# UNITED STATES PATENT AND TRADEMARK OFFICE

10/666,357

**Office Action Summary**

## DETAILED ACTION

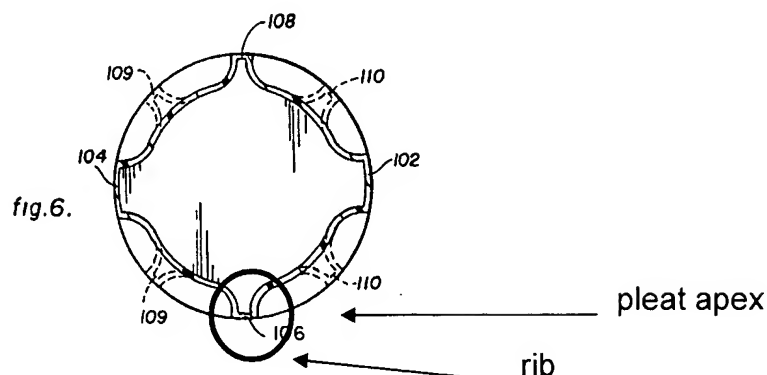
*(a) Even combining the Smith and Serkes reference, the resulting hypothetical combination does not provide for the collar in Smith to be flush with the pleats. Rather, the collar will protrude radially outwardly from the circumference of the container, including protruding radially outwardly from the pleated and unpleated sections.*

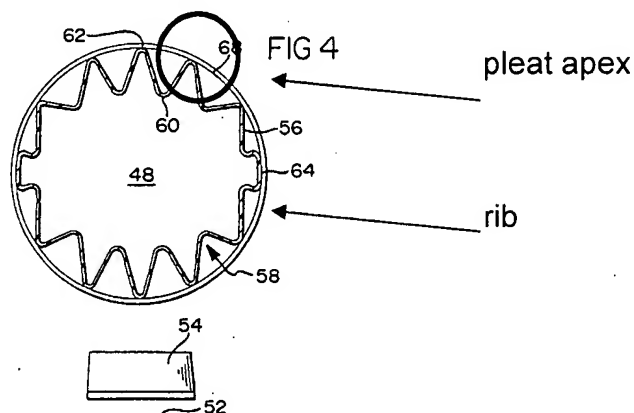
Contrary to the position advanced by Applicant, the ribs disclosed by Serkes are flush with the outermost portions of the apices of the pleats, and therefore are materially different in their construction in comparison to the ribs disclosed by Smith.

It is clear from Figure 6 that the vertical ribs 106 are flush with each horizontal pleat apex (unlabeled). This is different than the apparatus disclosed by Smith which indicates that the horizontal ribs are superimposed on top of the vertical pleat apices.
